Maelor Foods, Pickhill Lane, Cross Lanes, Wrexham

Variation of Condition 07 of planning permission

APP/H6955/A/18/3216187 (P/2017/1032) to permit the processing of 2,000,000 birds per week

Response to Wrexham Council Highways Comments

Figure 1: Daily Profile of HGV Arrivals Only (2 million birds per week)

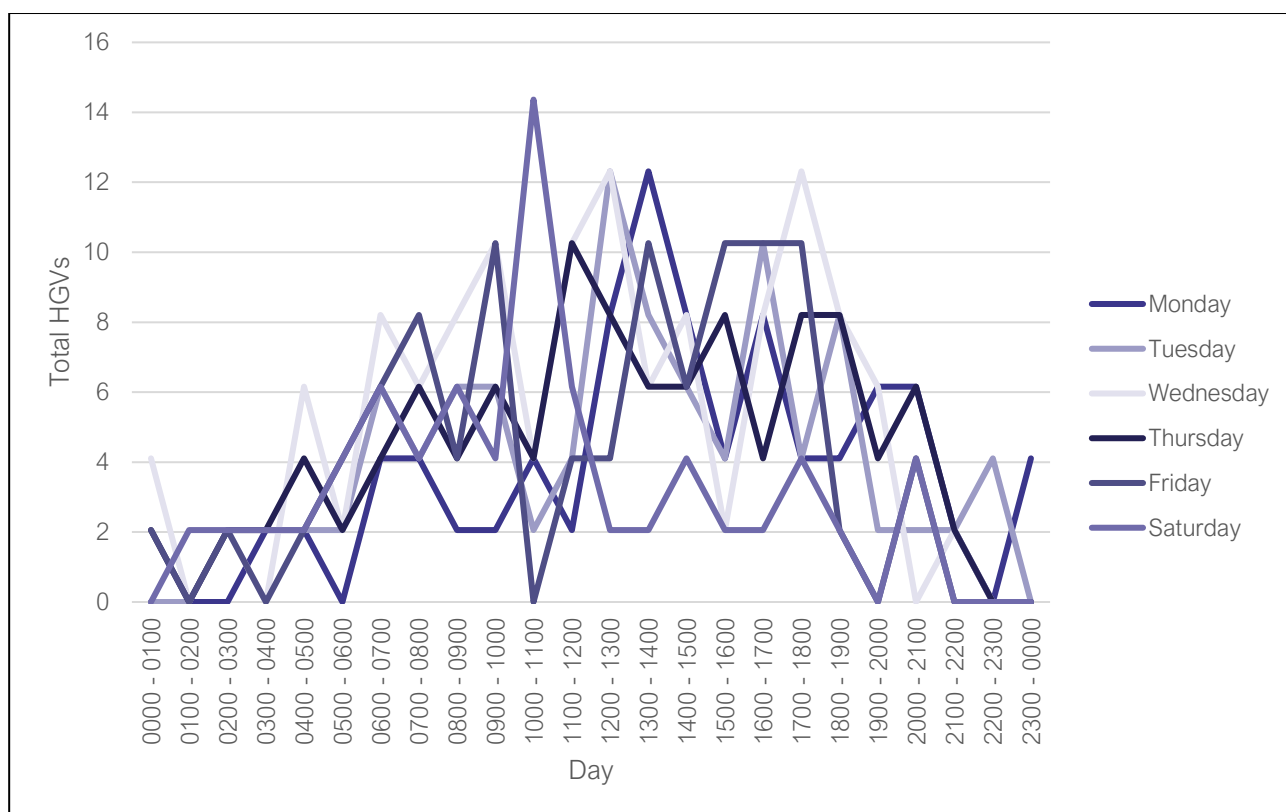
It would also be beneficial to understand the arrival times of HGVs, in order to ensure there are arrangements in place should more than one HGV arrive at the same time.

10. Within the submitted TA, an hourly two-way movement (arrivals + departures) profile was presented. As was presented in the TA, with the processing of 2 million birds per week, the maximum number of HGV two-way movements in a single hour could be 29 (worst-case / peak hour), with the majority of movements occurring in the interpeak periods.
11. For the purpose of this highway response, the data has been further interrogated to produce a HGV arrival only profile, for the processing of 2 million birds per week – refer to **Figure 1**.

12. As is shown from **Figure 1**, with the processing of 2 million birds per week, there will be a maximum of 14 arrivals in a single hour (worst-case / peak hour), which equates to approximately one movement every 4 minutes. The majority of arrivals will occur in the interpeak period.

13. To ensure that appropriate arrangements are in place, during all operational hours, HGV movements are currently coordinated and arrivals pre-booked in advance (where possible); the booking system will operate as such that the allocated arrival time of each HGV will be staggered across each hour so no more than one HGV will arrive at one time.

Figure 2: Indicative Pedestrian Route to/from Pickhill Lane

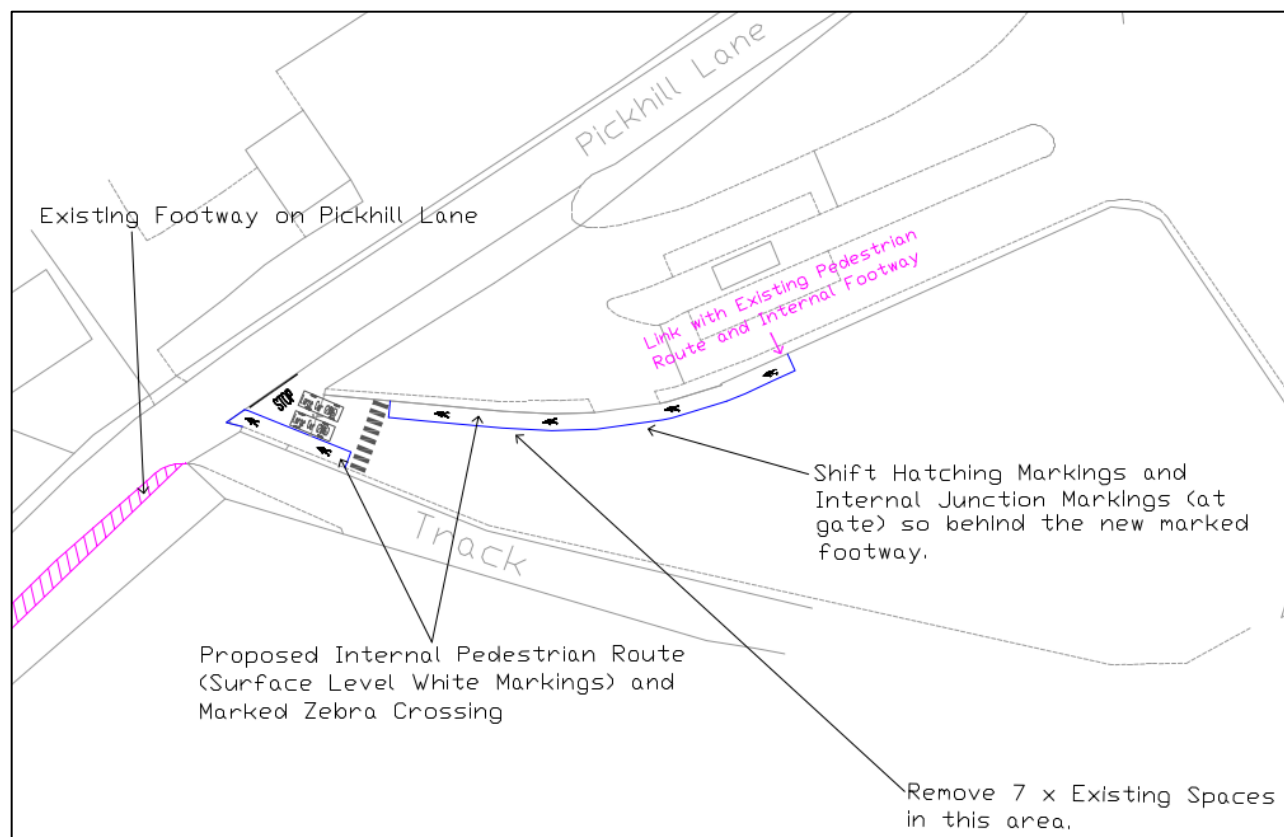
To improve access to the site on foot a designated footway for pedestrians should be provided. A detailed plan showing a designated footway is required.

17. Consideration has been given to the key pedestrian desire lines off the public highway / Pickhill Lane and the existing internal footways around the site.
18. Under the proposals, a 2m wide surface level marked pedestrian route from Pickhill Lane could be implemented at the main staff access. Through the use of appropriate signage, white lines and relocation of parking spaces, a delineated pedestrian route can be separated from the main access used by HGVs to minimise potential conflicts.
19. An indicative sketch of the proposed layout is provided as **Figure 2**.

Figure 3: Suggested Car Park Modifications

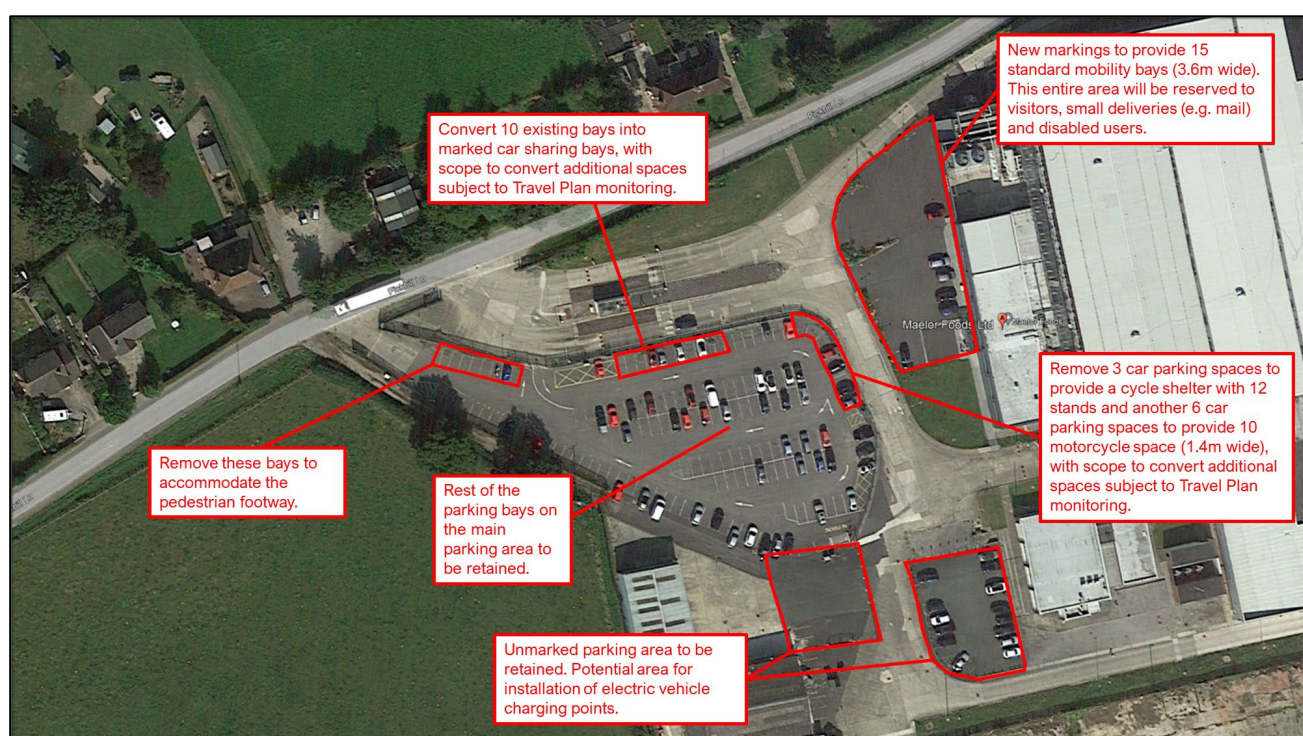
It is not known from the TA and planning application what the current parking arrangements are. Full details of the car parking arrangements are required. The applicant should provide car parking numbers and a plan illustrating the number of staff parking bays/ visitor parking spaces, the parking layout, drop off and pick up areas, and turning areas and should also detail what the arrangements are for staff shift changeovers. Detail regarding the number of accessibility parking bays, motorcycle spaces and cycle parking spaces is also required, as well as detail regarding cycle parking facilities, including secure lockers.

Clarification regarding staff shift patterns is required and assurance that there is enough space within the staff carpark for shift change overs is required.

28. The indicative analysis highlights that the existing car parking provision is sufficient for the future development demands, including shift changeover times. The maximum occupancy of the car parking on site is 121 vehicles, leaving 119 spaces available.
29. Although no additional car parking, or development area is proposed on the site, it is acknowledged by Maelor Foods that space within the car parking areas could be more formally defined to identify specific disabled, motorcycle and cycle parking space.
30. As such, suggested modifications to the existing car park are presented in **Figure 3** which shows the potential for dedicated disabled parking close to the main building entrance, conversion of standard spaces to car sharing spaces, conversion of standard spaces to create motorcycle spaces and removal of spaces to provide secure, covered cycle parking.

31. It is considered that the suggested modifications identified in **Figure 3** could be implemented as part of the existing Travel Plan monitoring and review process. If all areas shown were to be implemented, the final number of spaces on site would be as follows:
 - 215 car parking spaces, including 15 'mobility standard' bays;
 - 14 cycle parking spaces; and
 - 10 motorcycle parking spaces.

Figure 4: A525/Pickhill Lane Proposed Dimensions and Geometry

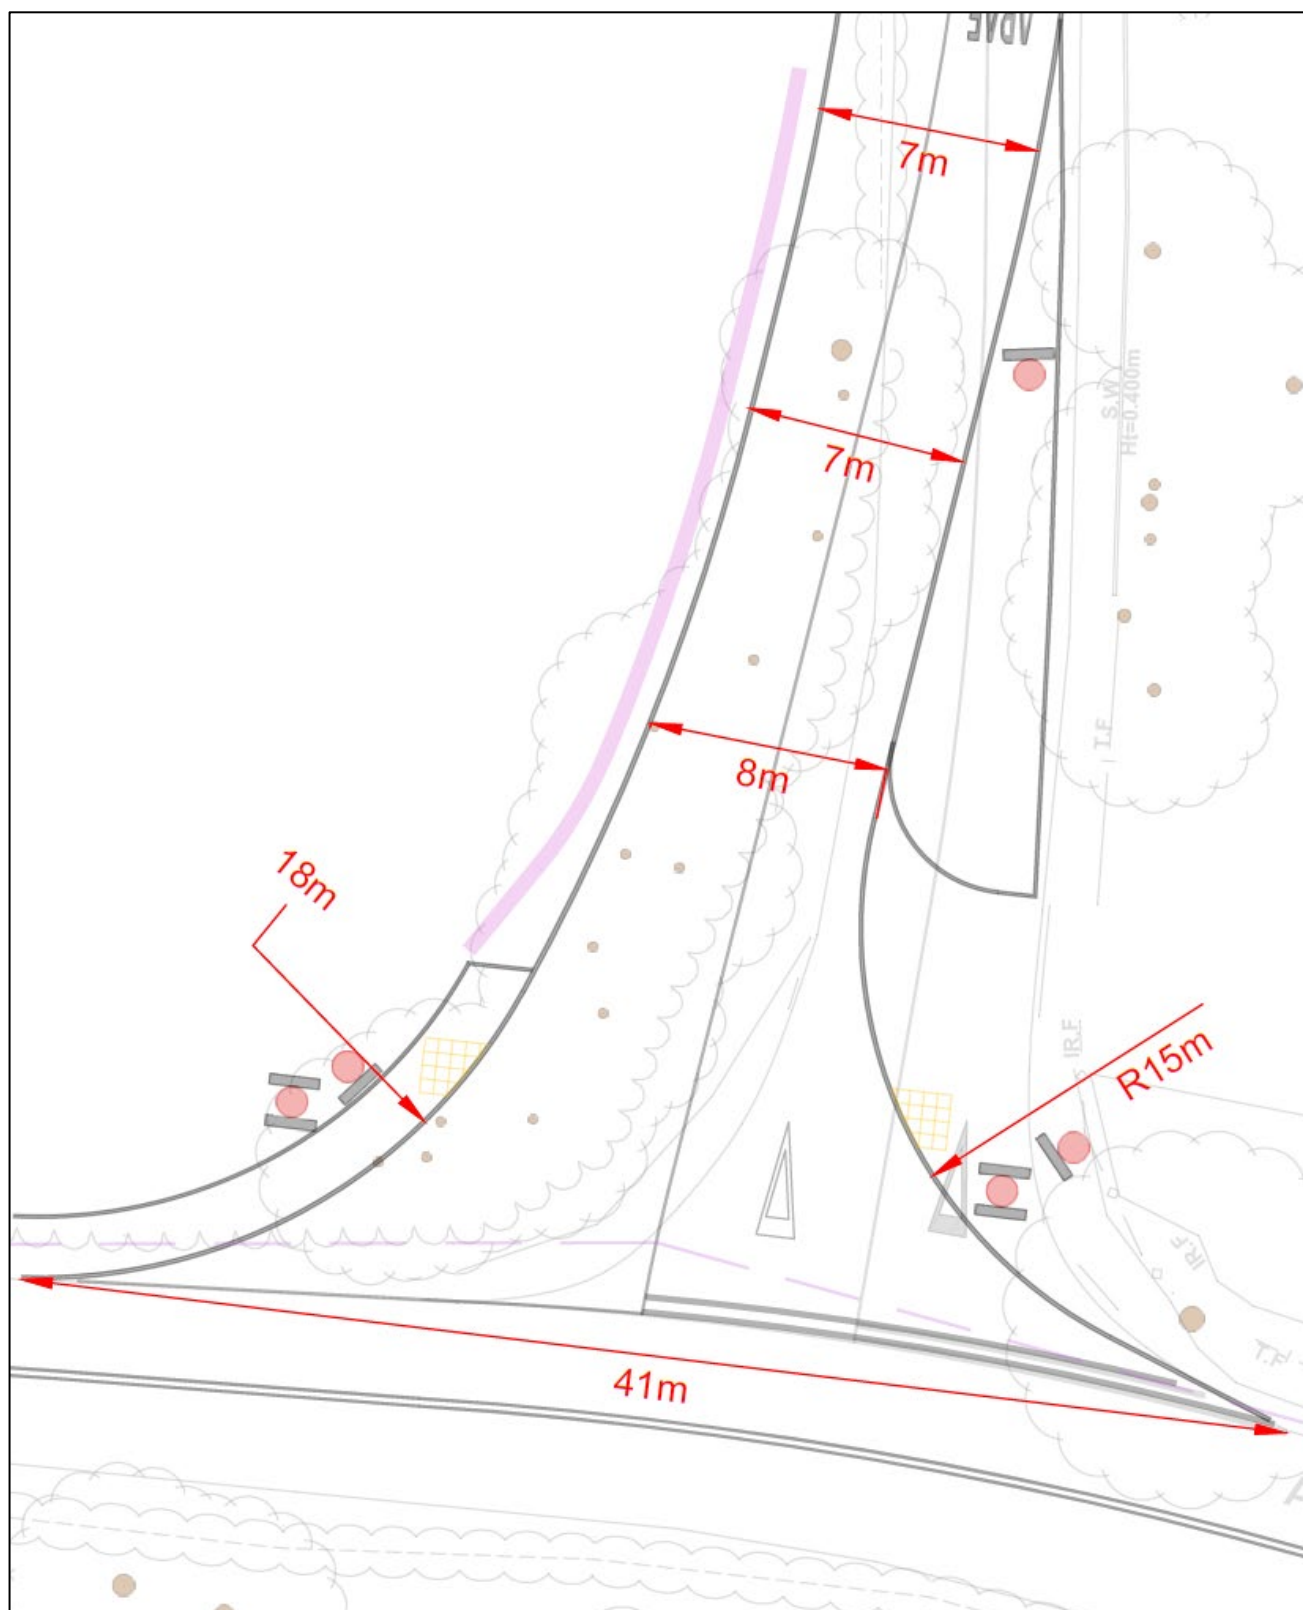
A proposed layout plan has been provided; however, it is requested that a detailed design is provided for approval with dimensions of the proposed layout on the drawing.

33. The proposed layout plan presents a general arrangement for the A525/Pickhill Lane junction including visibility splays, markings, footways, tactile paving, indicative extent of retaining structure and suggested replacement signage locations.
34. At this stage of the planning process, it is considered that a full detailed design of the junction is not necessary to inform a planning judgement on the variation of condition application. This level of detail can reasonably be conditioned.
35. However, to assist in providing additional information, key dimensions at the junction are presented in **Figure 4**.

DRAWING TITLE:
Site Access Visibility Splay

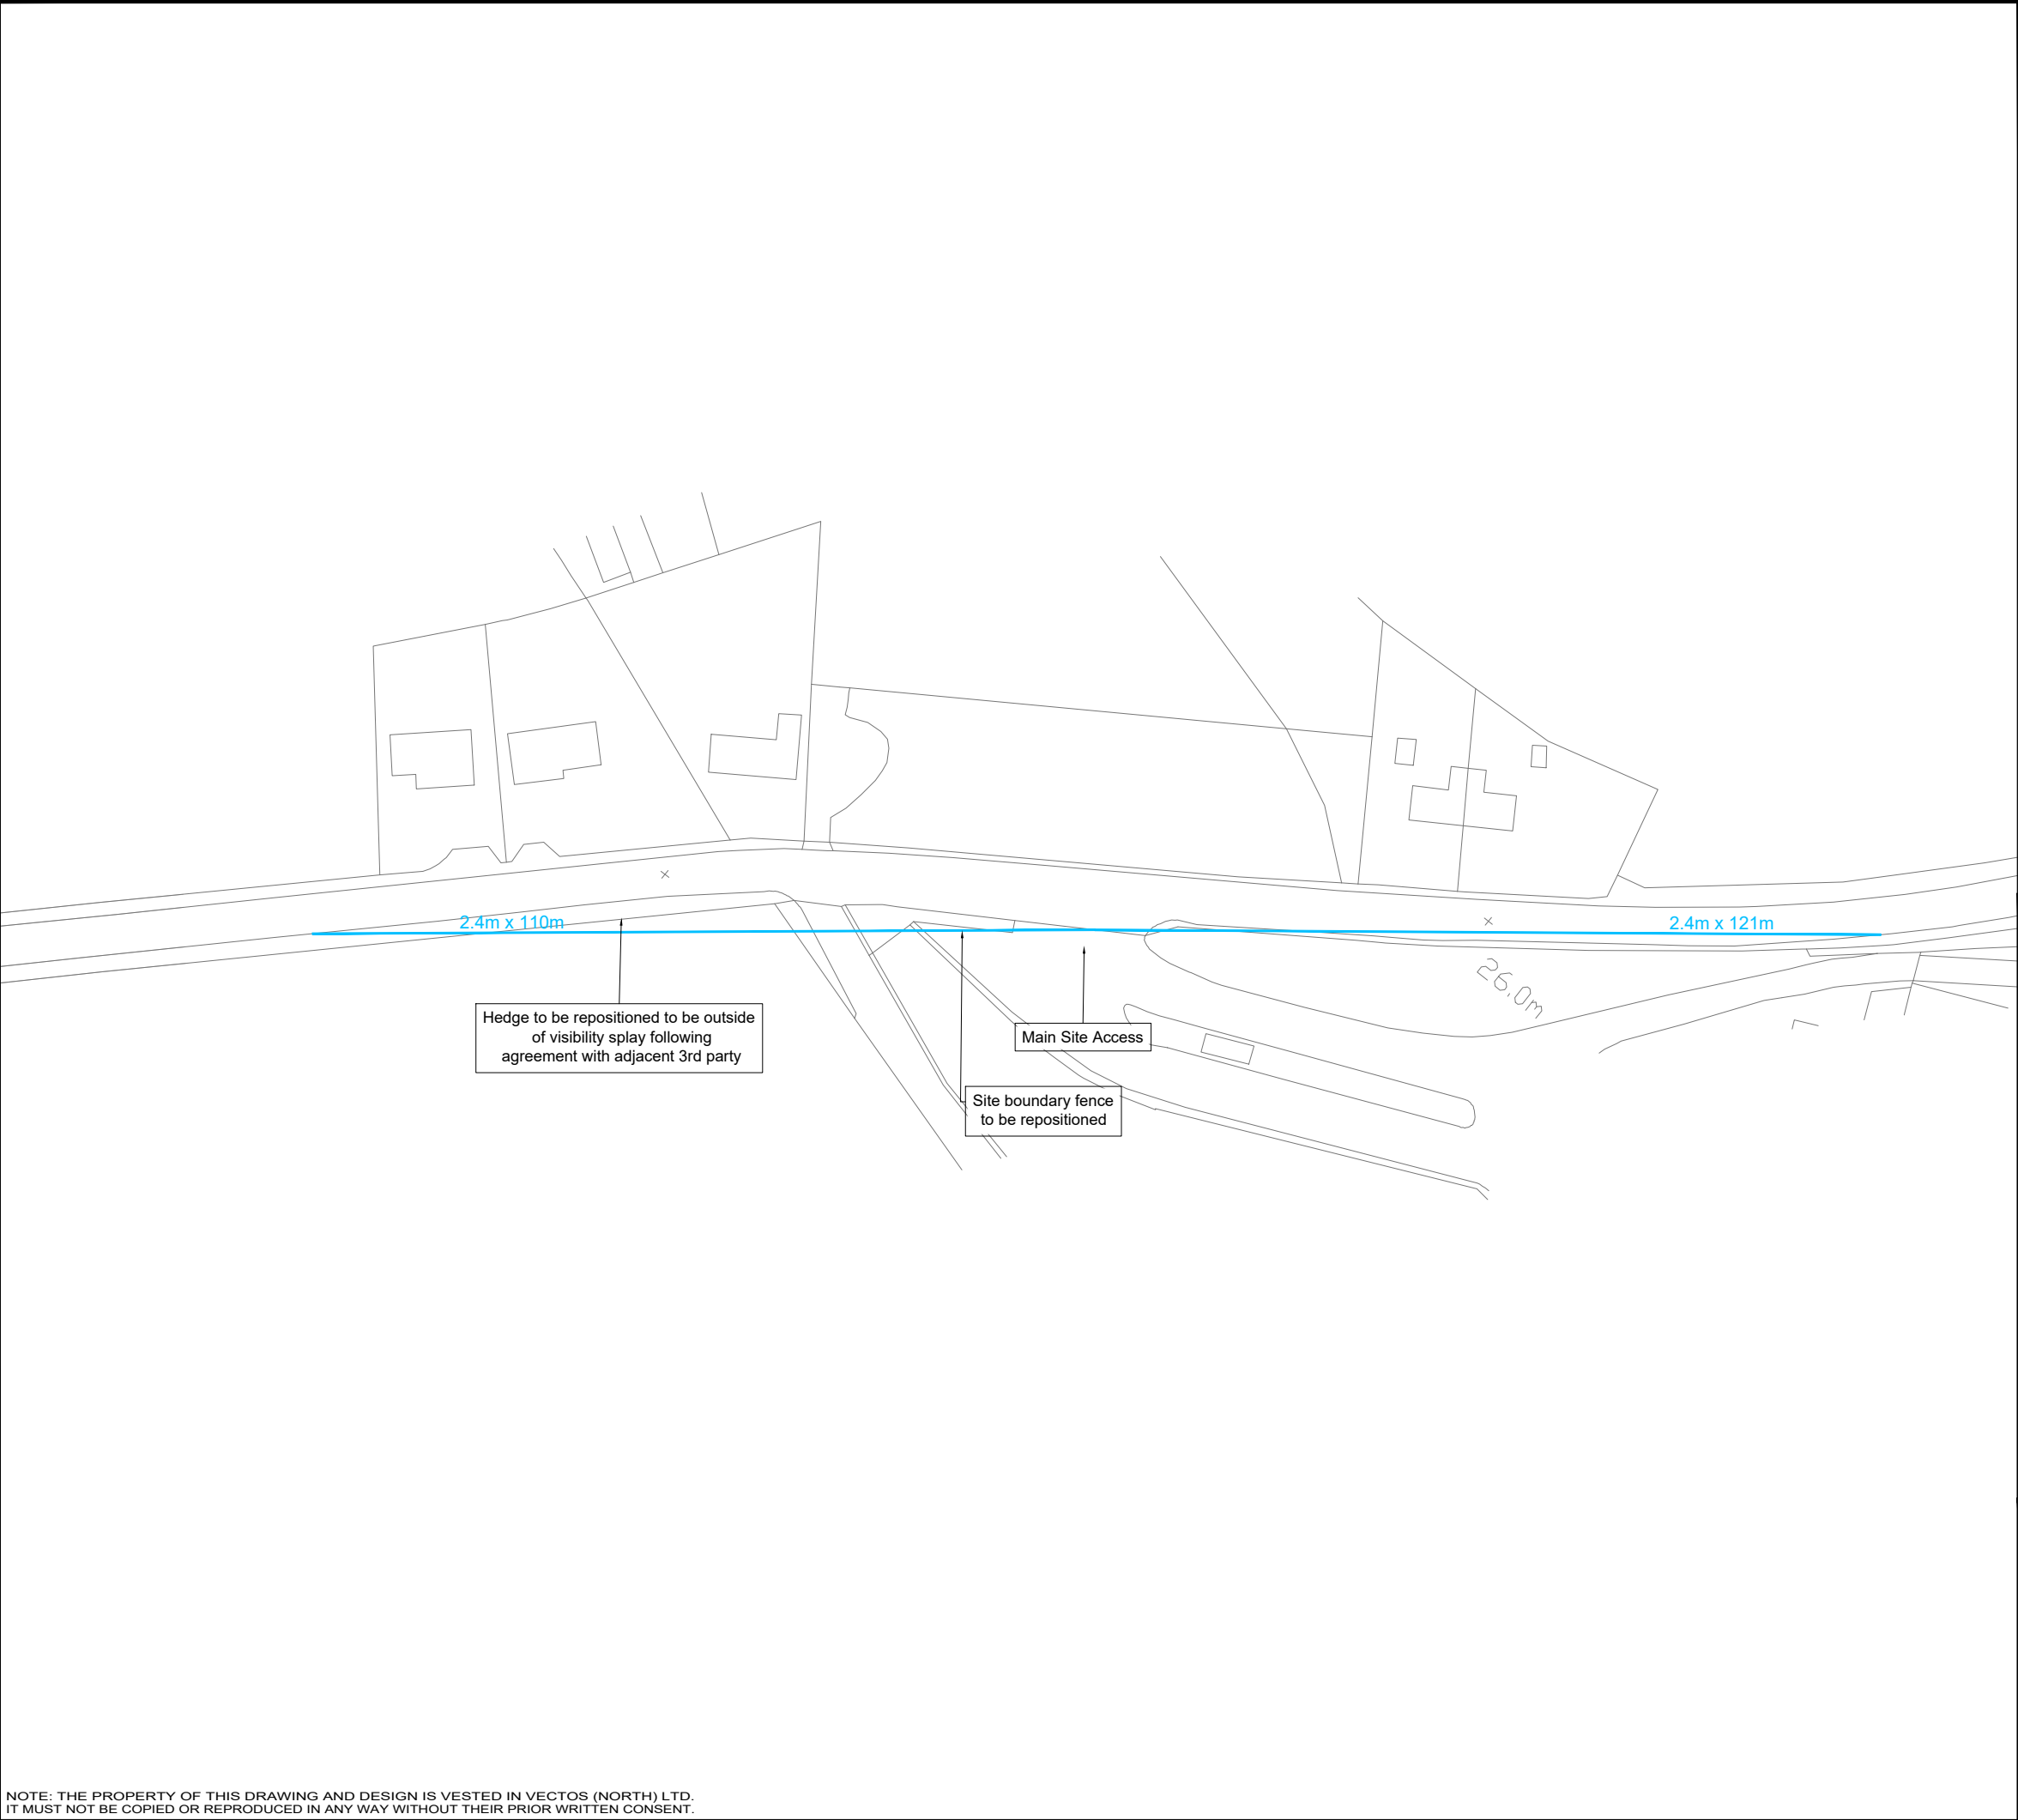
It is not unreasonable to request plans showing visibility splays for HG's exiting the site and also staff / visitors exiting the site via the separate staff and visitor access point.

7. A visibility assessment at the main staff and HGV site entrance was undertaken as part of a previous planning application at the site (refer to **Vectos Drawing VN70805-D106**). These were based on the recorded 85th percentile vehicle speeds on Pickhill Lane recorded in 2017. These were recorded at 41mph-44mph.

8. The visibility sightlines presented have previously been agreed with the Council and have been implemented on site.
9. For clarity, as part of the 2022 surveys, 85th percentile vehicle speeds on Pickhill Lane were also considered and reported in the Transport Assessment (37mph-38mph). The recorded speeds are less than previously recorded and therefore the visibility splays currently achievable at both site access points is sufficient for the development demands.
